## 08-29 NIKE LIVE - CARY, NC

### Project Issue Information

sf1\_cary.jpg

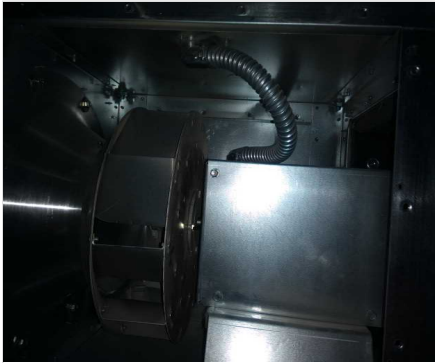
**Description :** EMS HAS NO CONTROL OVER FAN SPEED, THEIR SYSTEM SAYS SF1 FAN WAS NOT RUNNING WHEN FAN WAS RUNNING 100%. THERE IS NO SPEED CONTROLLER INSTALLED ON FAN. FAN BLADES ARE ALSO GRINDING REALLY BAD, FAN WAS SHUT OFF TO PREVENT DAMAGE FROM OCCURRING. THESE ISSUES WILL NEED TO BE RESOLVED BETWEEN EMS AND MECHANICAL FIELD TECH WHO INSTALLED CONTROLS.

- **08/31/2022**      **National TAB - Andrew Loignon**
  - SF1 IS OPERATIONAL, HOWEVER COMFORT CONTROL SYSTEMS CAN NOT ADJUST FAN SPEED THROUGH THEIR SYSTEM DUE TO FAULTS, RESULTING IN SF1 NOT BEING ABLE TO BE BALANCED CAUSING THE INABILITY FOR OA OF FCU 1-4 TO BE BALANCED.
